CITY OF JOPLIN
Zora Street and Duquesne Road Intersection Improvements

Addendum No. 3

ADDENDUM NO. 3

PROJECT:	Zora Street & Duquesne Road Intersection Improvements Joplin, Missouri
BID OPENING:	10:00 a.m., June 06, 2024 602 S Main St. 4th Floor Joplin, Missouri

GENERAL LAYOUT

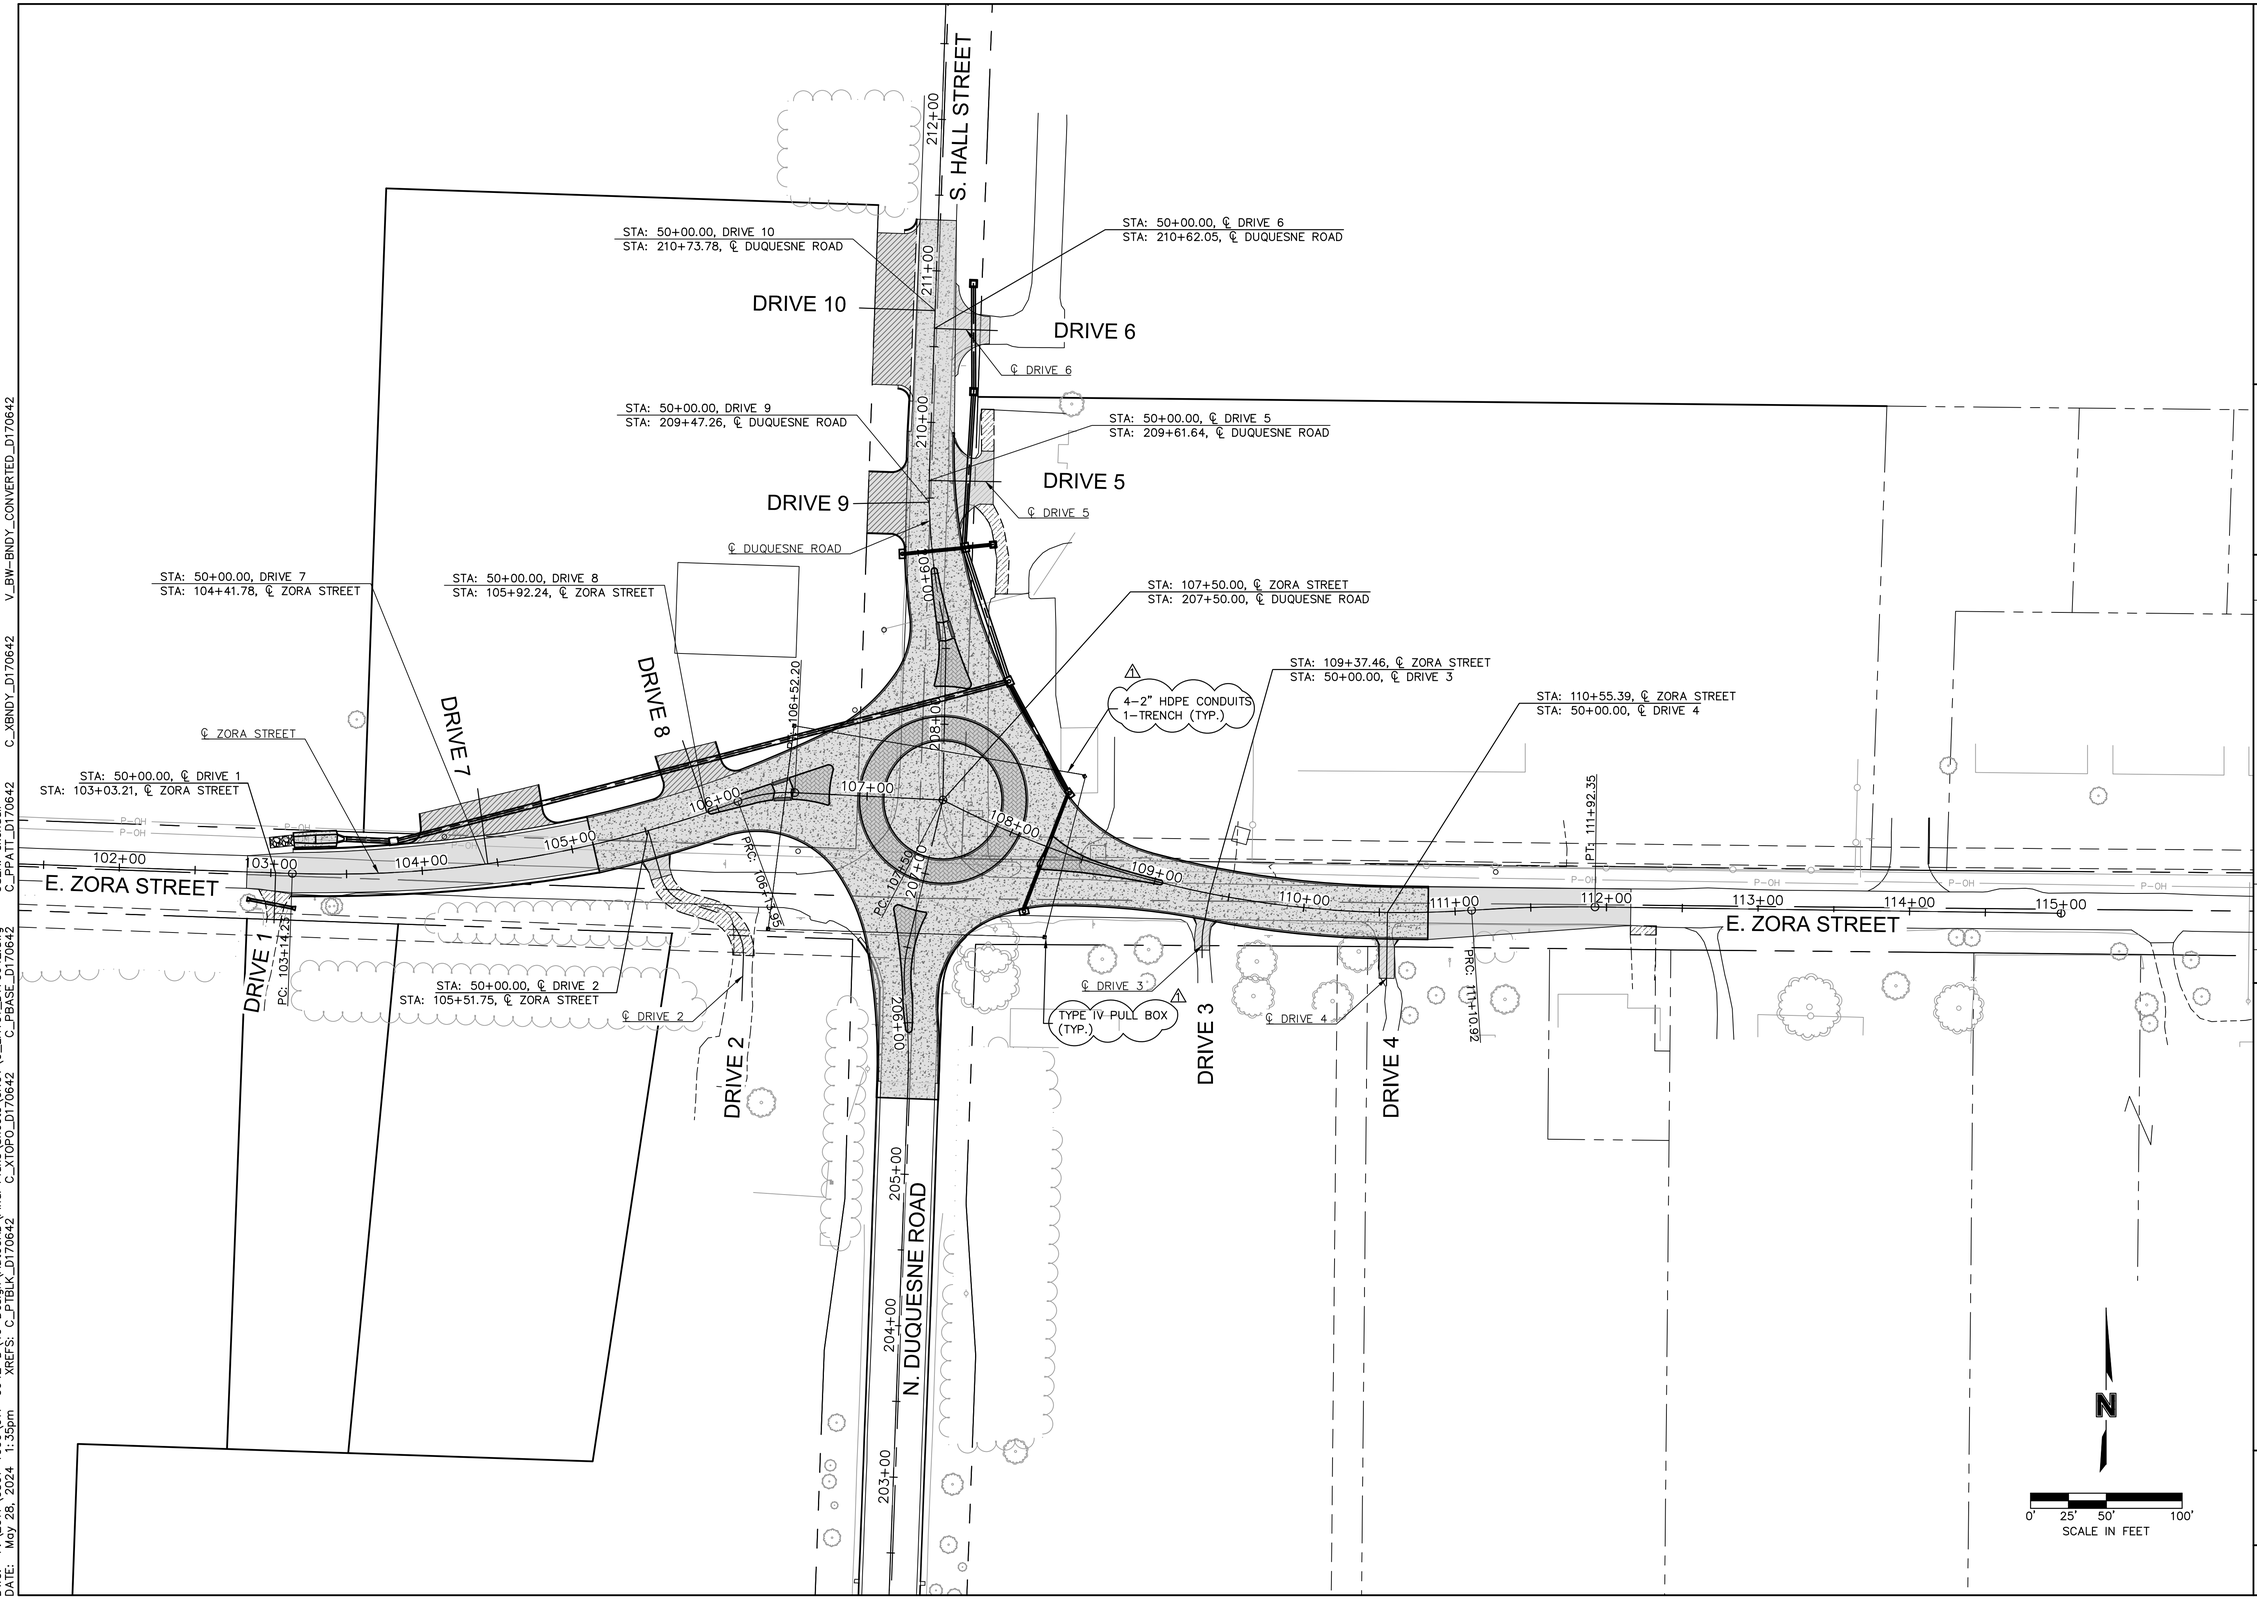
1. Sheet 2 – General Layout
    a. Location of Proposed Fiber Conduit and Pull Boxes
2. Sheet 7 – Summary of Quantities
    a. Update MoDOT Barrier Curb
    b. Add Fiber installation quantities.
3. Sheet 19 – Roadway Plan and Profile
    a. Location of Proposed Fiber Conduit and Pull Boxes
4. Sheet 21 – Roadway Plan and Profile (East Leg)
    a. Location of Proposed Fiber Conduit and Pull Boxes
5. Sheet 39A – Fiber Optics Details
    a. Add details for fiber conduit installation

REV. NO.	DATE	REVISIONS DESCRIPTION	BY
1	5/24/2024	ADDENDUM #3 - FUTURE FIBER OPTIC CONDUIT	SMK

FIBER OPTIC DETAILS

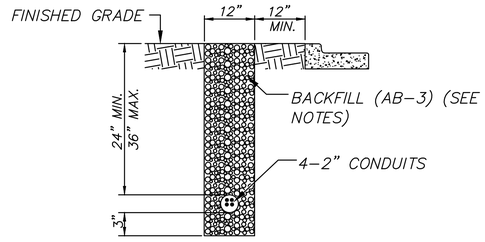
REV. NO.	DATE	REVISIONS DESCRIPTION	BY
1	5/28/2024	ADDENDUM #3 - SHEET ADDED	SMK

TRENCHING NOTES:
1. ALL TRENCHES FOR CONDUIT UNDER ROADWAYS SHALL BE BACKFILLED WITH FLOWABLE FILL.
2. CONDUITS SHALL BE PITCHED TO DRAIN.
